Final Environmental Impact Statement

Proposed Four-Lot Subdivision

Incorporated Village of East Hills, New York

FINAL ENVIRONMENTAL IMPACT STATEMENT

3.5.2.5 Stopping Sight Distance Analysis

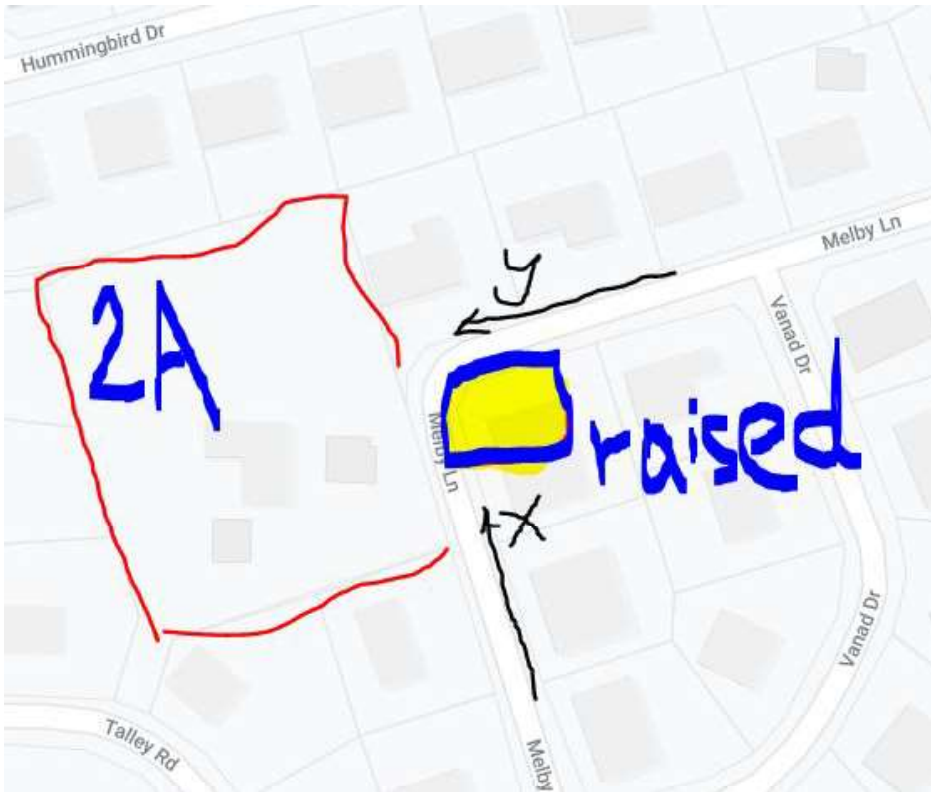
“the sight distance analysis concluded the SSD is approximately 260 feet when looking to the right”

I find this number incorrect.

PRELIMINARY MAP OF MELBY COURT GRADING AND DRAINAGE
Of Property Situated In The
Inc. Village of East Hills Nassau County, N.Y.

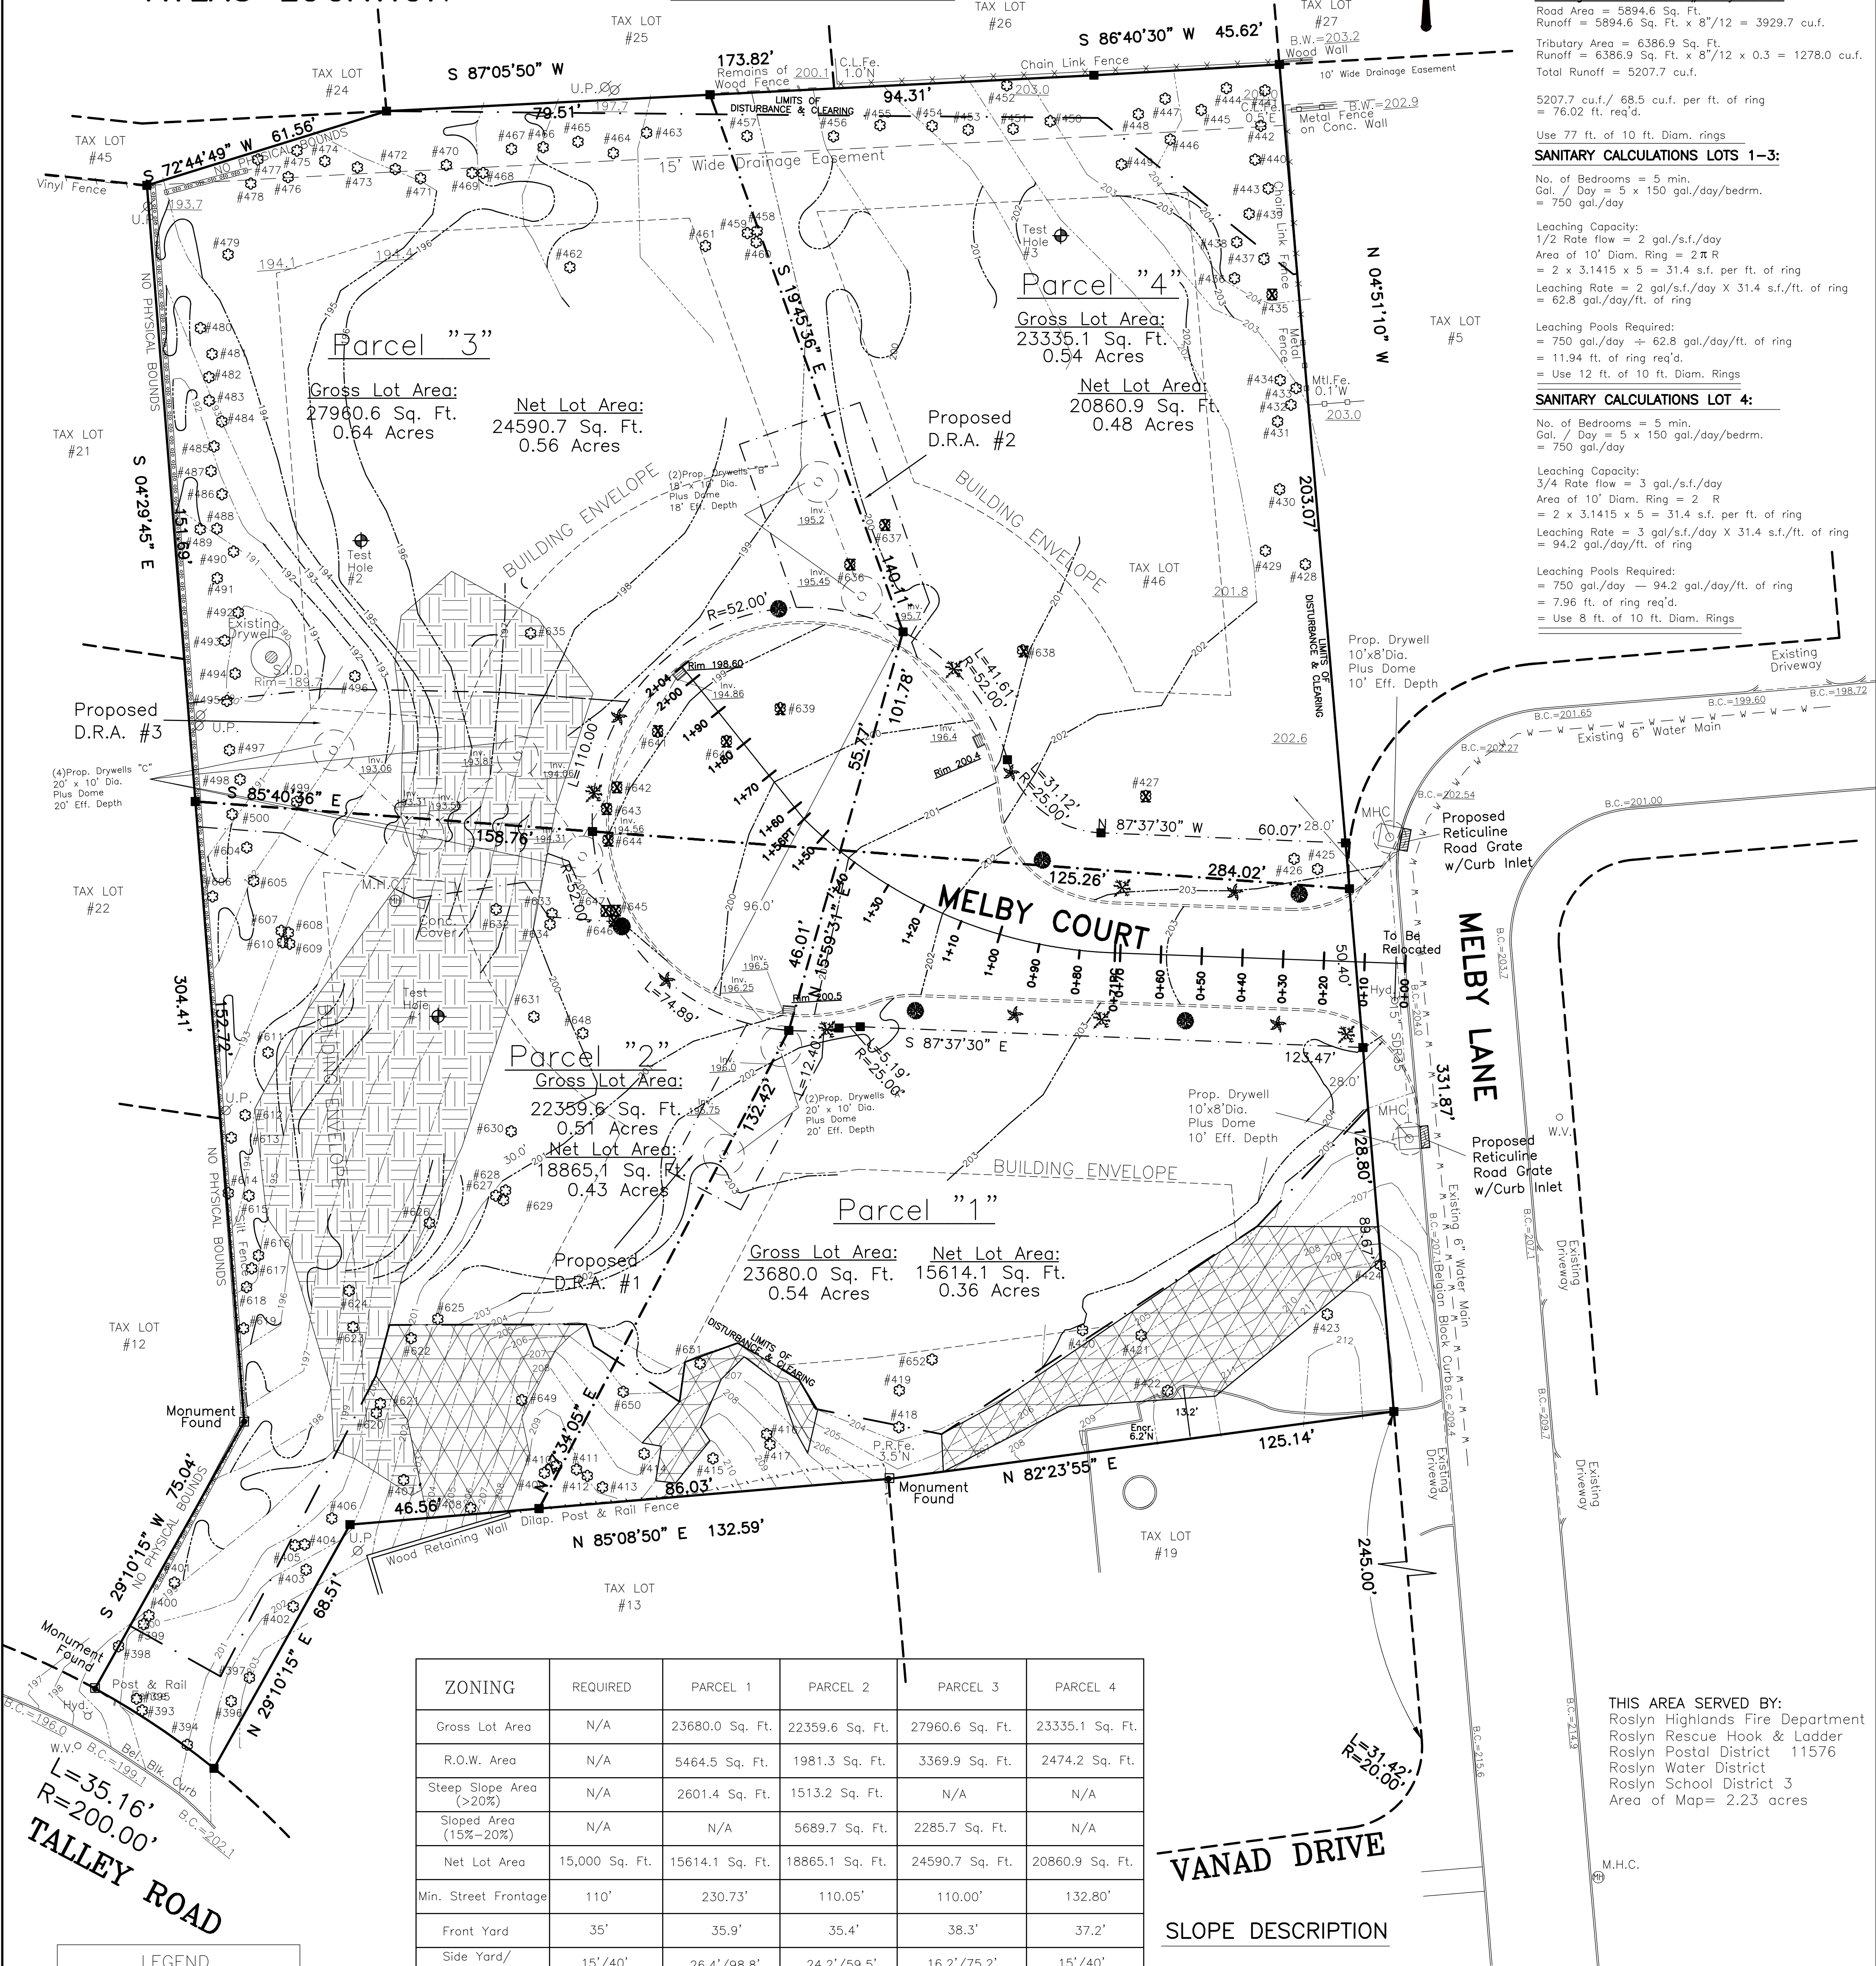
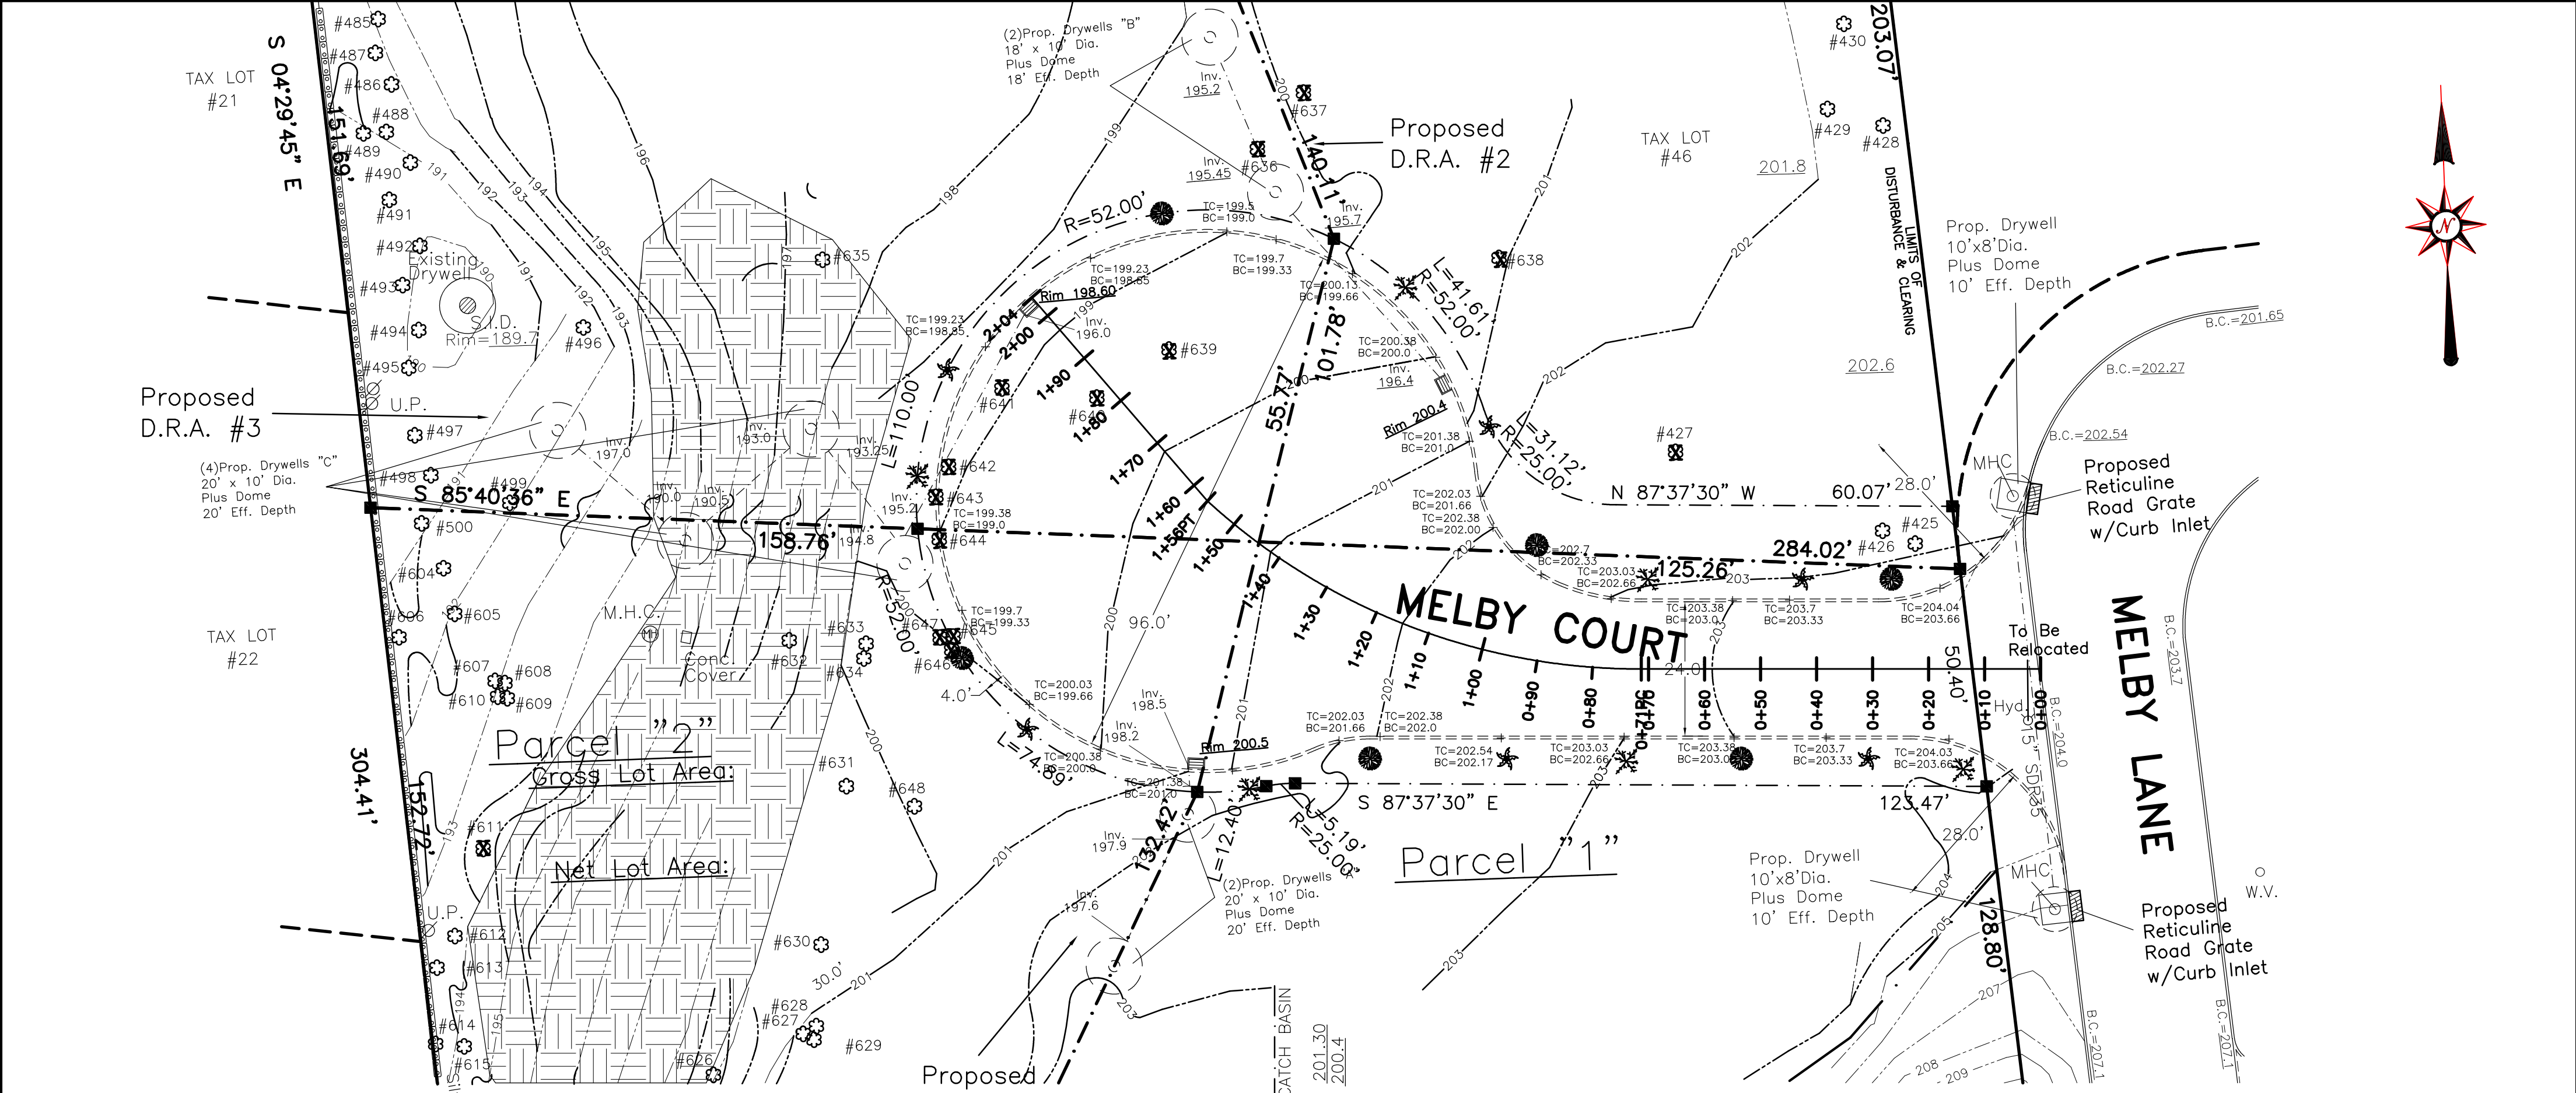
The Preliminary Map Sheets 5-7 should be updated to provide the area of slopes between 15%-20%. The necessary disturbances to steep slope areas should be quantified based on the comments above, and updates to analysis of impacts assessed accordingly.

The high water elevation should be indicated as the maximum elevation of stormwater storage within the leaching rings of leaching pool (bottom of pool to top of leaching rings/bottom of dome). No drainage piping should be installed within dome. The Table of drainage structures (Sheet 7 of 8) should be revised as necessary to ensure this.

All drainage calculations for the proposed lots have been revised to reflect an eight-inch rainfall event. Additional drywells have been added to accommodate the piping of roof leaders directly to drywells and not intermingling roof drainage with site drainage. All drainage structures and drainage calculations have been revised to reflect stormwater runoff from the complete site (see Sheet 7 of 8 in Appendix E of this FEIS).

Proposed spot elevations have been added to each of the proposed lots on Sheet 7 of 8 (see Appendix E of this FEIS). Slope percentage has been added to indicate the maximum slope of the driveways and the parking areas.

All proposed roof drainage is shown on Sheet 7 of 8 piped directly to drywells and separated from site drainage (see Appendix E of this FEIS).

A drainage structure chart has been added to the detail sheet (Sheet 7 of 8) indicating all requested elevations, as well as on each of the plans (see Appendix E of this FEIS). All drainage structures have been shown with invert elevations to show compliance. See also response to L6-31.

ROAD PROFILE

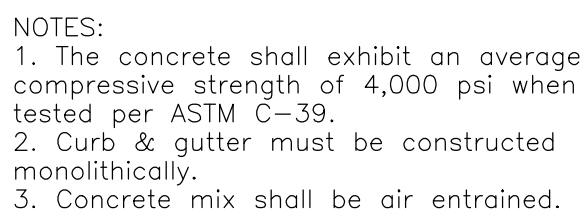
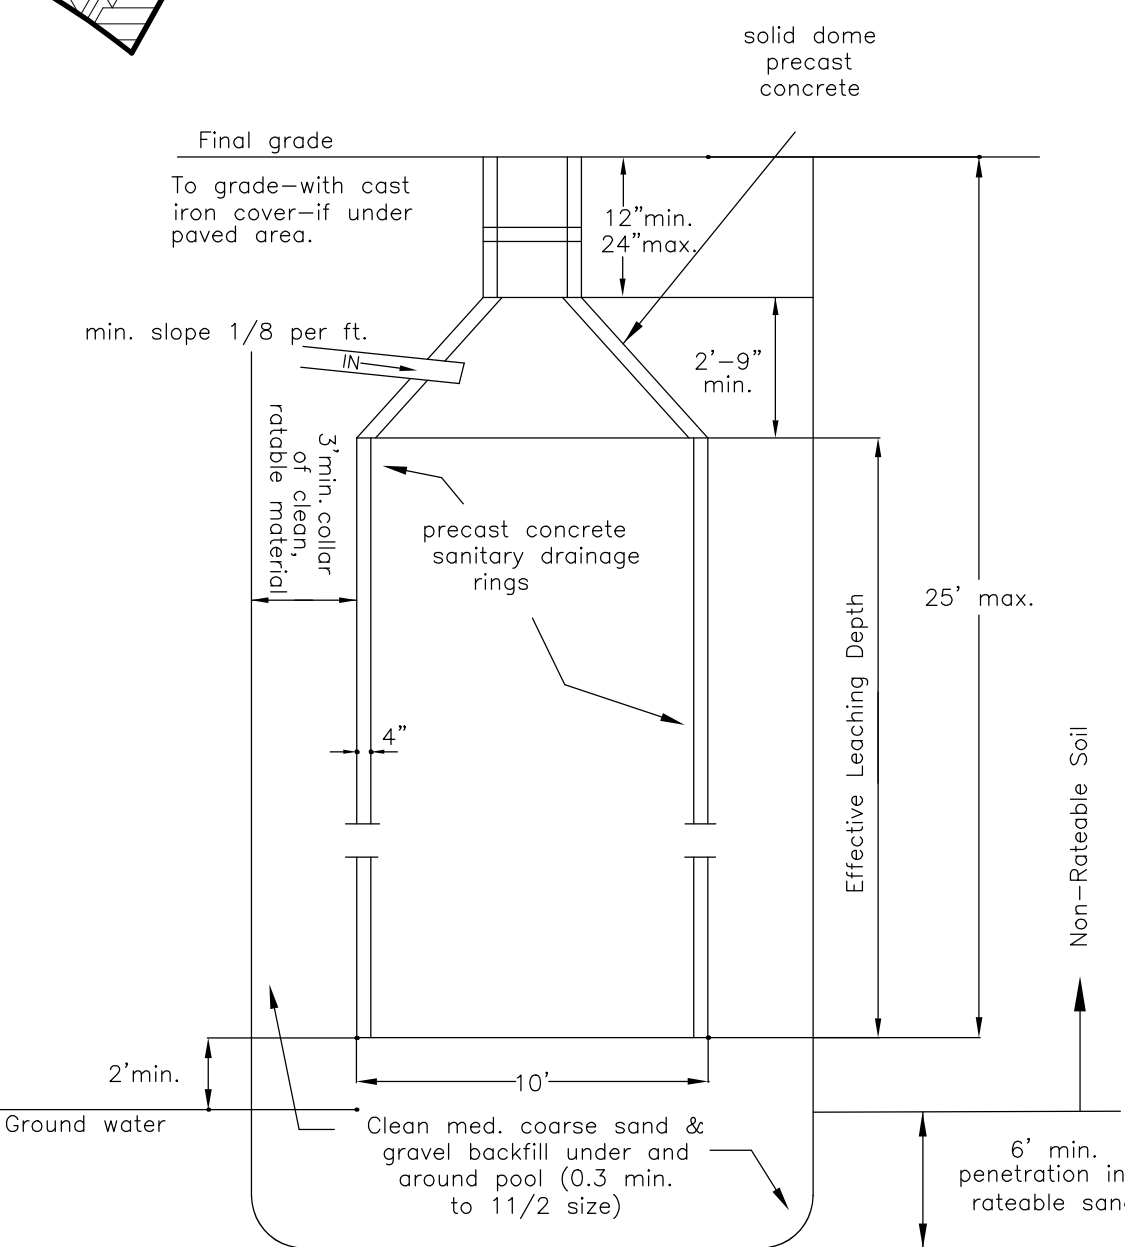
The top of curb grades around the cul-de-sac road profile are provided on Sheet 4 of 7. Top of curb elevation is provided every 10 feet around the proposed roadway. However, the centerline road profile and cul-de-sac curb profile do not correspond with each other correctly. CB1 and CB2 do not have the same rim elevations in each profile and plan. The cul-de-sac profile should begin corresponding to Station 0+71 of the road profile. The top of curb and gutter elevations should also be indicated on cul-de-sac curb profile. This will need to be revised accordingly.
